Chrisanthy Semertzidis

Department of Transport and Planning

**PA2503647 – 675 Victoria Street, Abbotsford
Section 50 Request**

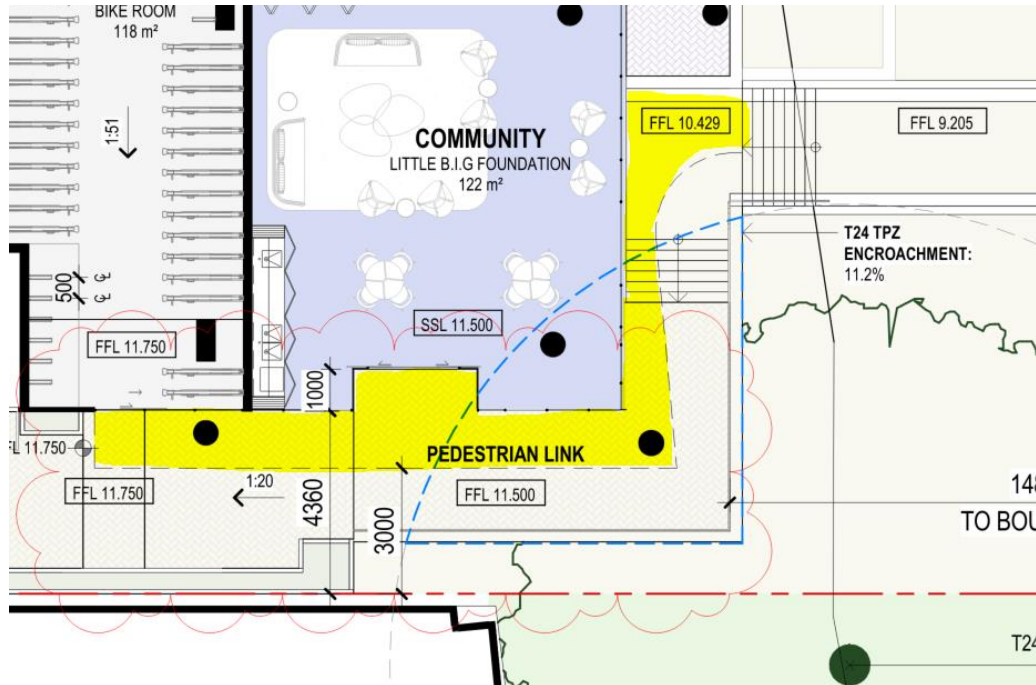
1. *We acknowledge the improved through-link connection from Victoria Street to the River Pathway that now includes a direct and clear line of sight. Consider the following:*
 - a) *Though we note Clause 11.03-6L (Victoria Street East Precinct) promotes improved pedestrian connectivity, it does not explicitly reference accessibility. In this regard, the DDA and overarching Clause 15.01-2S (Building design) necessitate equitable access, consider including a DDA compliant ramp (in accordance with AS 1428.1) where the staircase is proposed towards the river. Demonstrate an on-balanced approach (crown land, vegetation, other ramps) as to whether this level of design excellence is necessary and can be achieved.*

DDA access has been incorporated into the project design as much as practicably possible, including accessibility from Victoria Street, through the public link, to the entry of the community space on Lower Ground. There is approximately a 6.5m difference between the land landing outside the community space down to the Yarra Trail. In order to navigate this significant level change and ensure minimum disruption to the vegetation and Natural Ground Level of the landscaped riverbank (critical for Melbourne Water flood modelling), a direct set of stairs was deemed to be the best solution.

In order to accommodate a 6.5m level difference, it would be necessary to provide a 130m long 1:20 ramp (without taking landings into consideration). To meet the relevant standards, a landing would need to be provided every 15m. It is possible to avoid the requirement for landings if the ramp grade is reduced to 1:33, however this would lead to the ramp being around 220m long.

Given the significant amount of land that would be required to accommodate this, including the removal of significant trees, it is not possible to provide a ramp from the Yarra Trail. Further, it is not possible to provide a public lift given that this would open below the flood level and therefore not be permitted by Melbourne Water. A public lift would also necessitate extensive earthworks detrimental to the river environs.
